DOCUMENT 00 91 02 – ADDENDUM NO. 2

PROJECT: Ord Village Lift Station & Force Main Replacement Project

CIP NO.: OS-0147

ISSUED: January 15, 2021

**ORD VILLAGE FORCE MAIN REPLACEMENT
 PLAN & PROFILE (6 OF 6)**

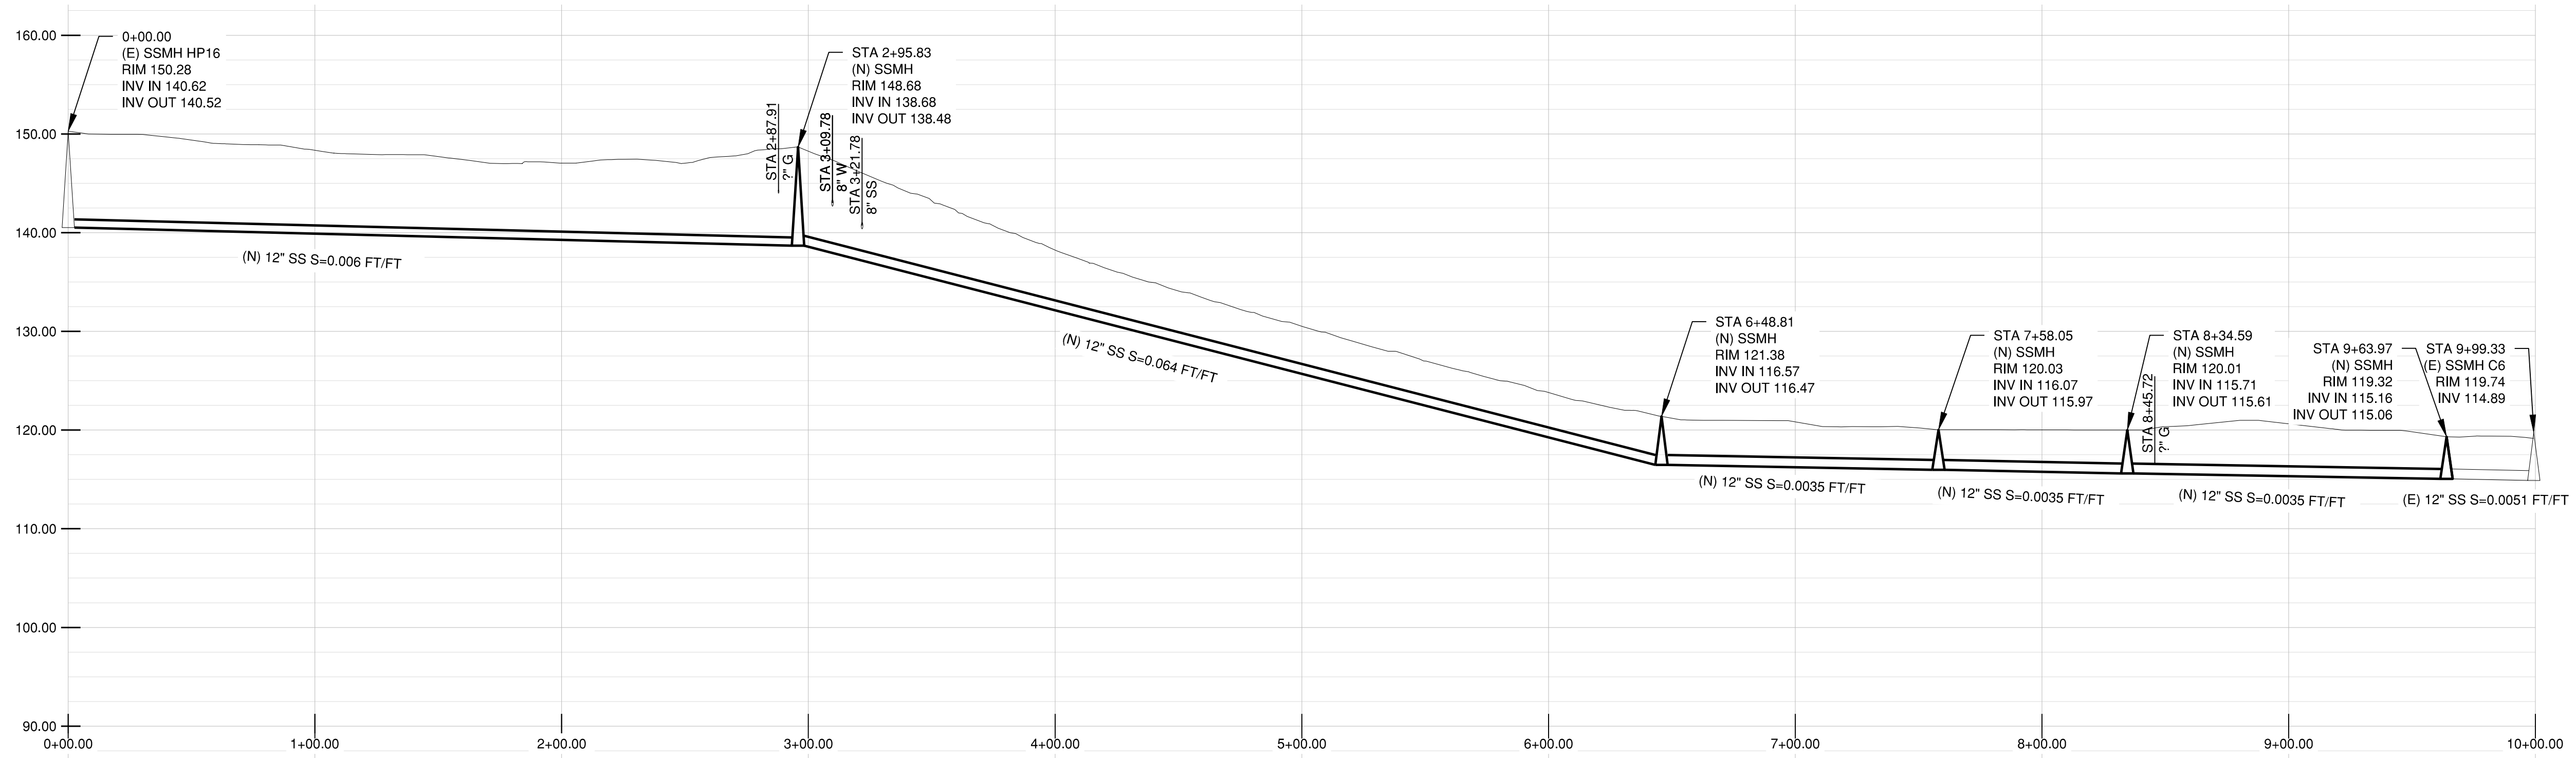
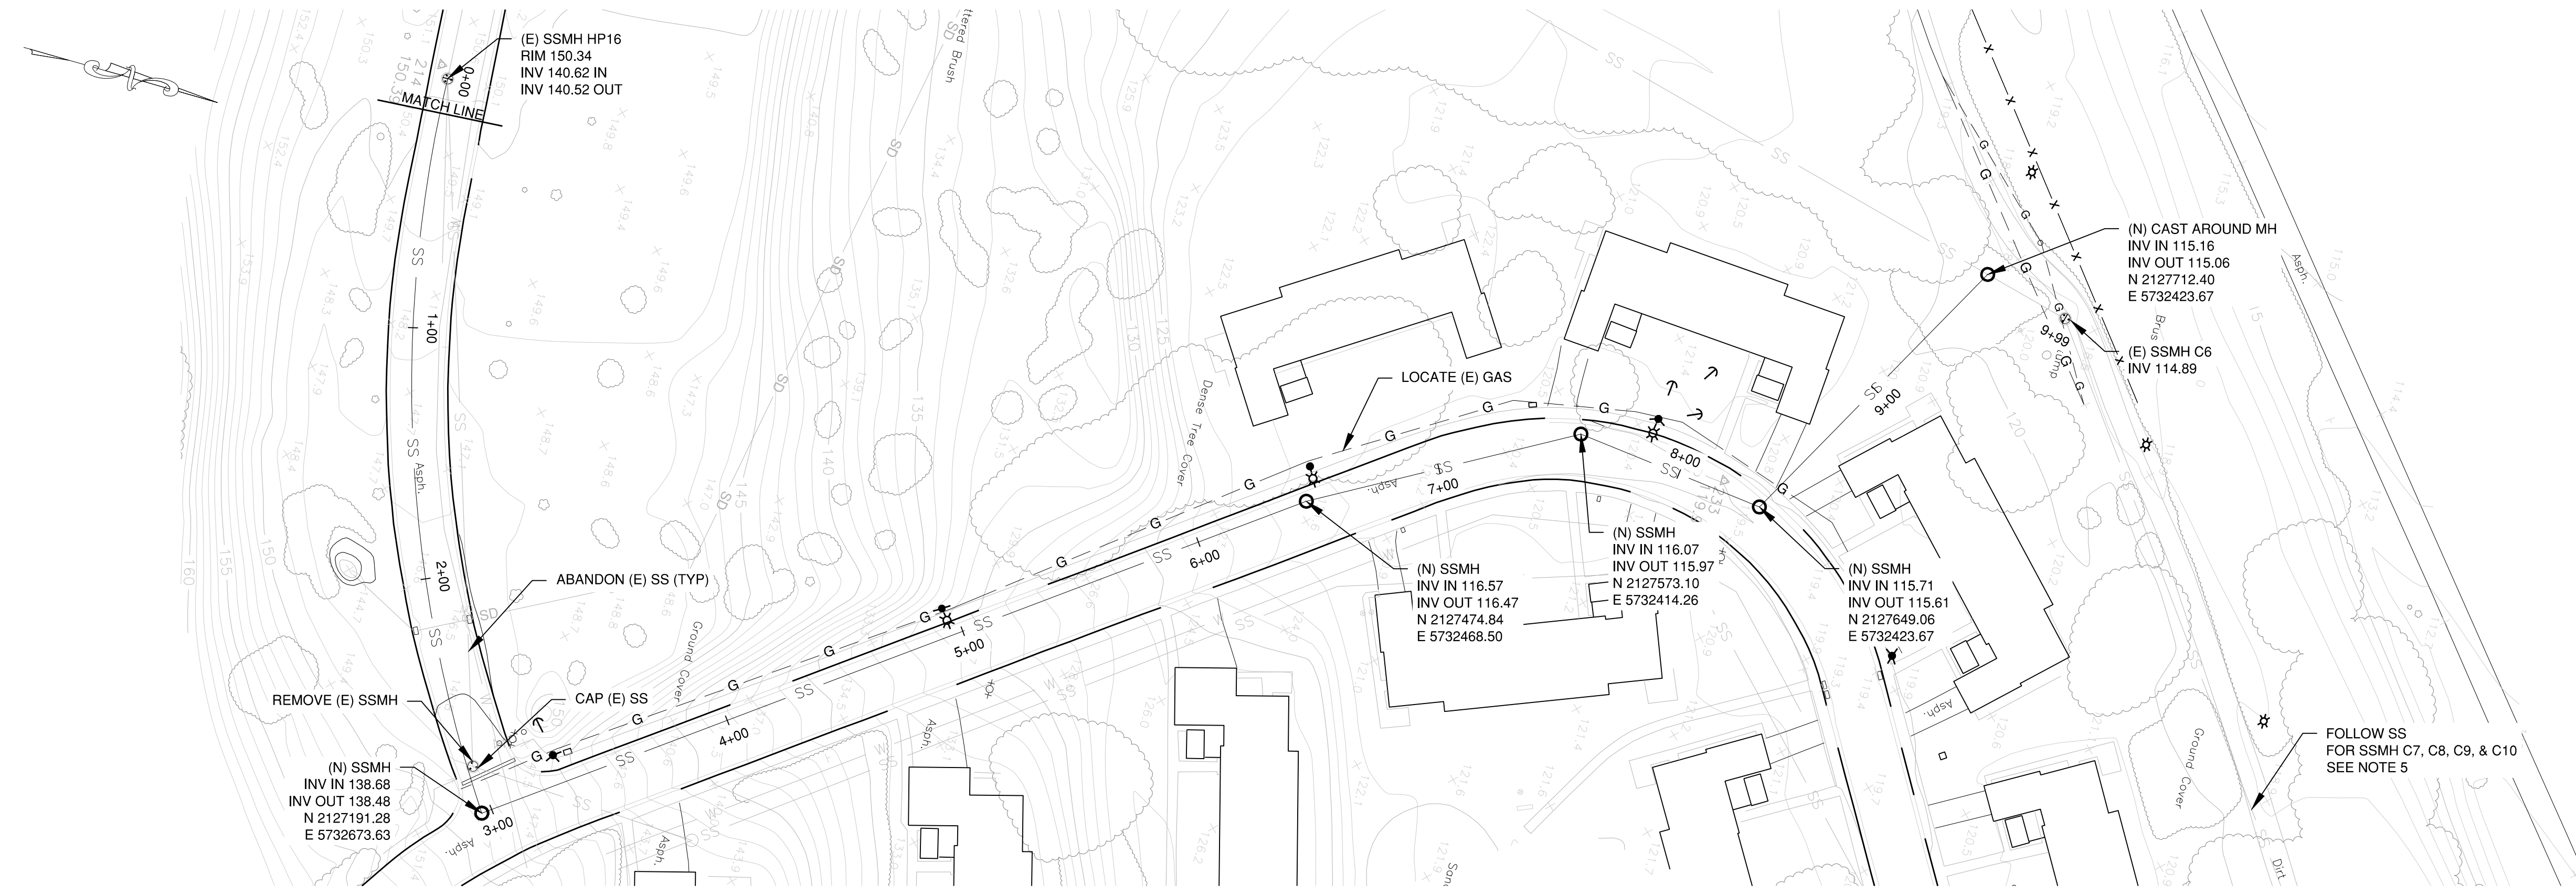
- A. Sheet 10, Plan & Profile (6 of 6) is reissued. A table of manhole depths is added.
- B. Sheet 15, Sewer Details (1 of 4), is reissued. Details for concrete foundation pads are added.
- C. Sheet 18, Sewer Details (4 of 4), is reissued. The label for Detail 1 is corrected.

Q7 Please provide the depth of manholes to be epoxy lined (C6-C10) referenced in item 15.

A7 A table is added to Sheet 10 listing the manhole depths.

**ORD VILLAGE FORCE MAIN REPLACEMENT
 SEWER DETAILS (1 OF 4)**

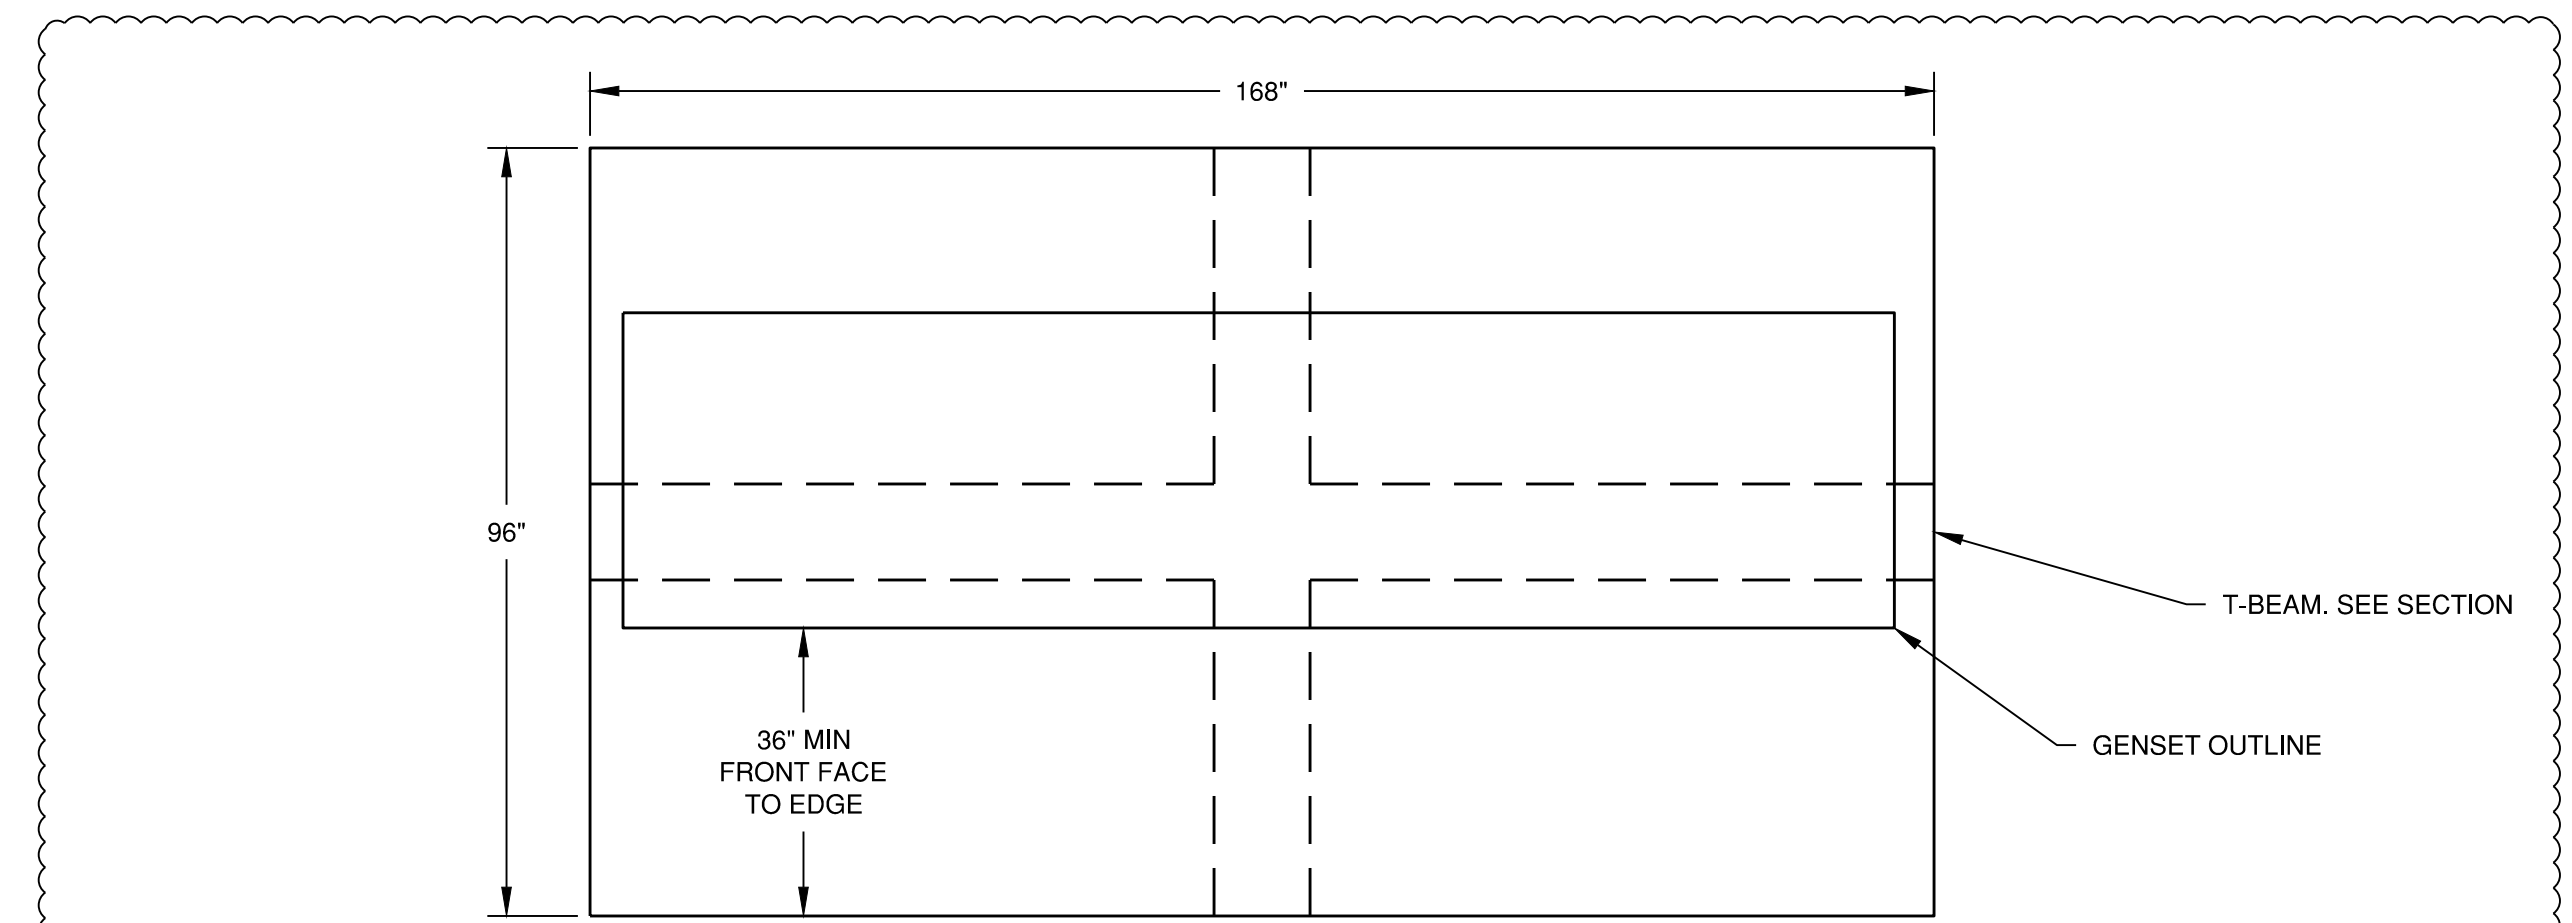
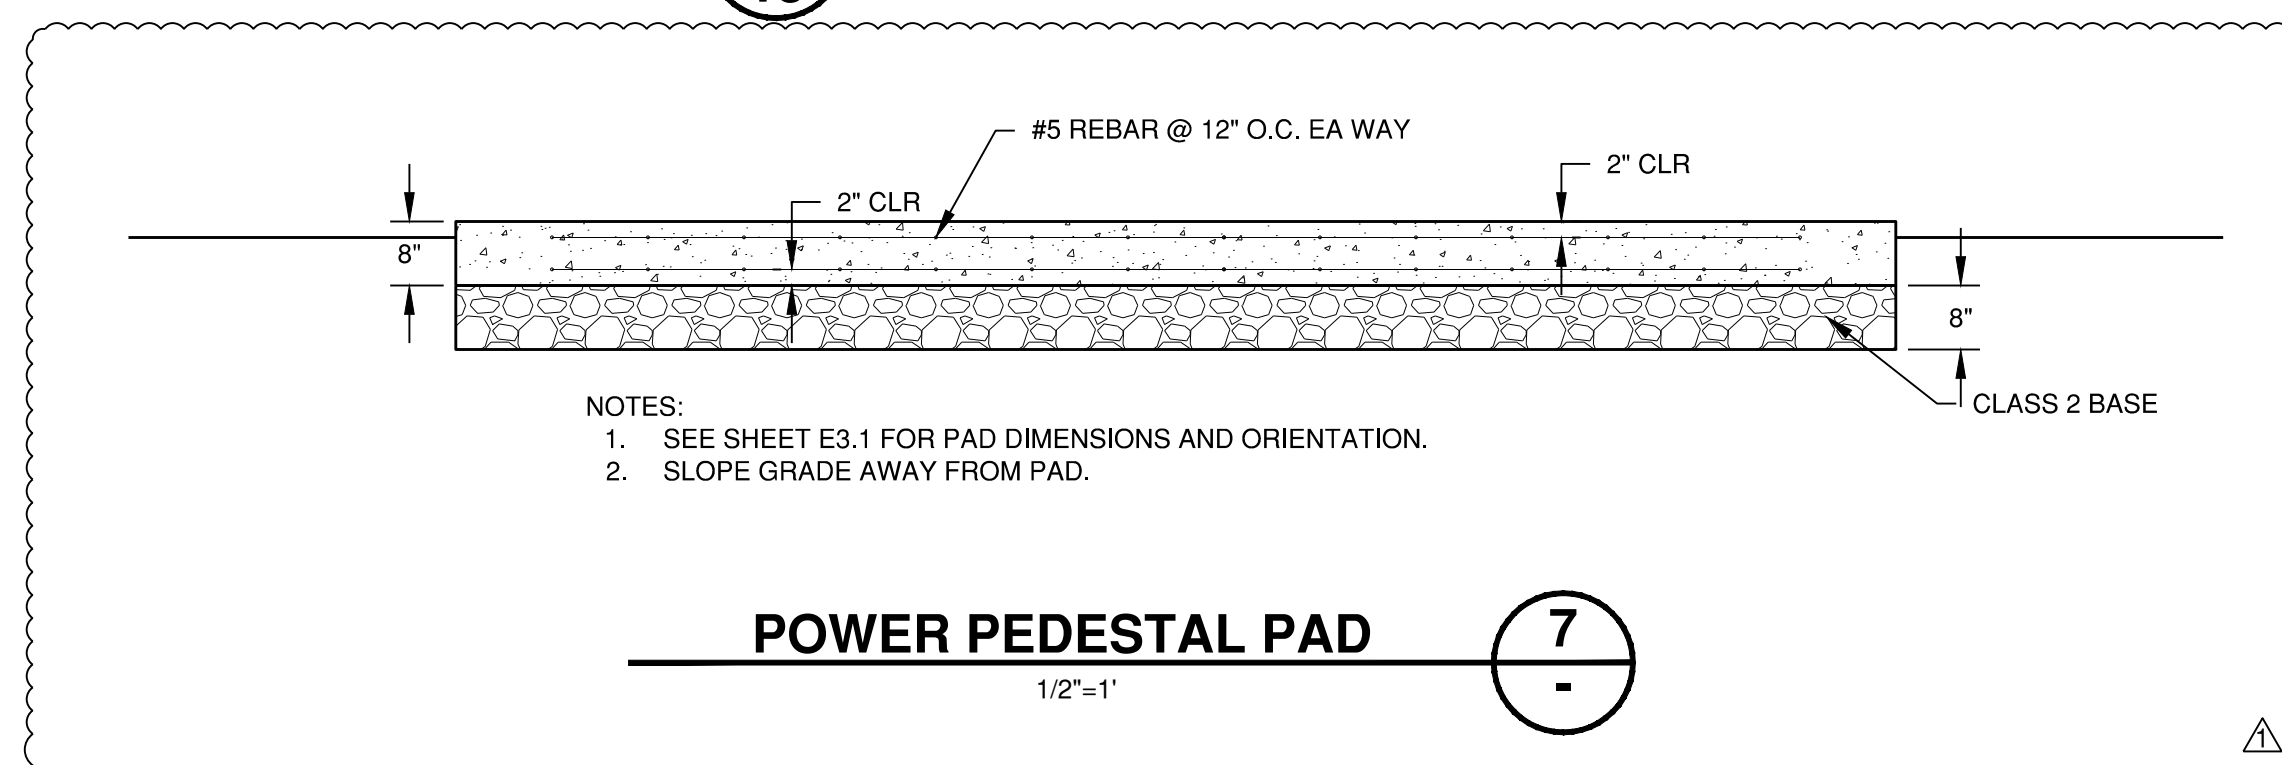
Q9 Is there a detail for the generator foundation slab?

A9 Details are added to sheet 15 for the generator and electrical equipment slabs.
